Civil Air Regulations Amendment 4b-6
Effective: August 12, 1957
Adopted: July 8, 1957

AIRPLANE AIRWORTHINESS, TRANSPORT CATEGORIES

MISCELLANEOUS AMENDMENTS RESULTING FROM
THE 1956 ANNUAL AIRWORTHINESS REVIEW

FIGURE 4b-25a

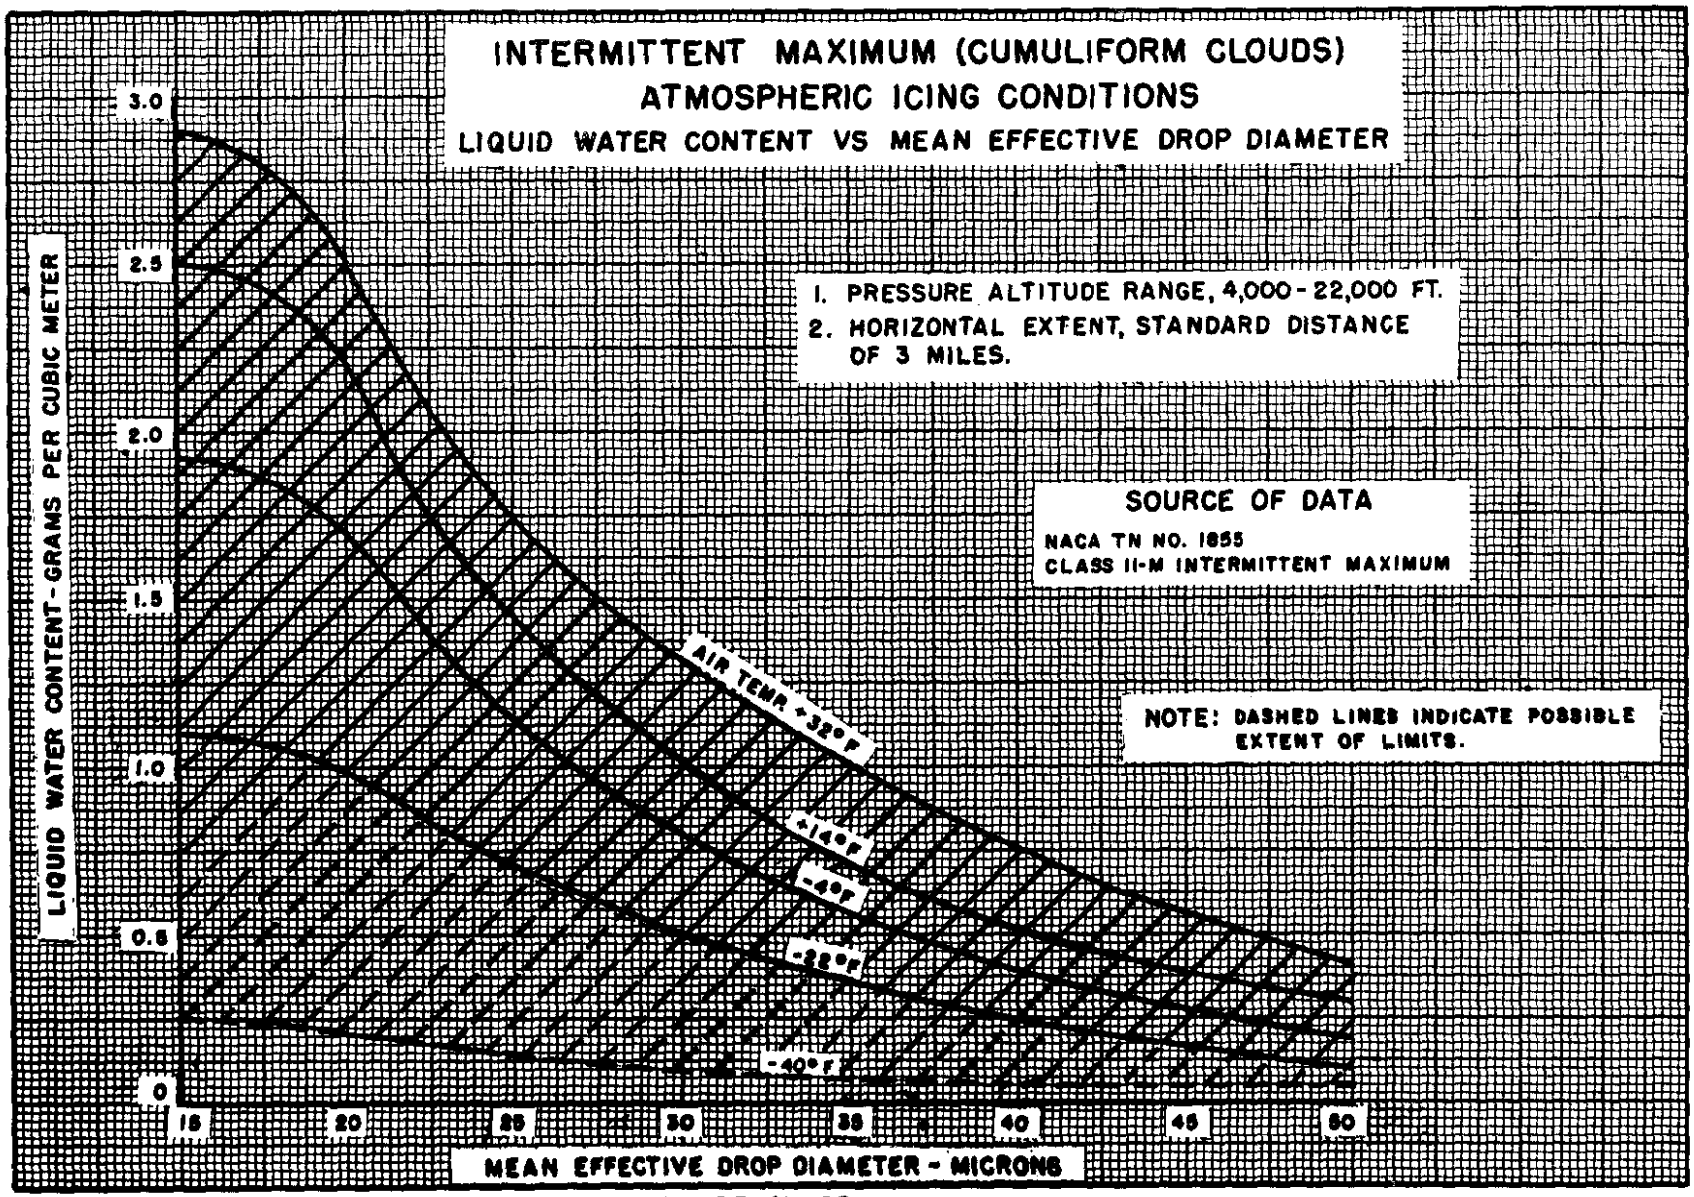
46. By amending Figures 4b-25a and 4b.25c.
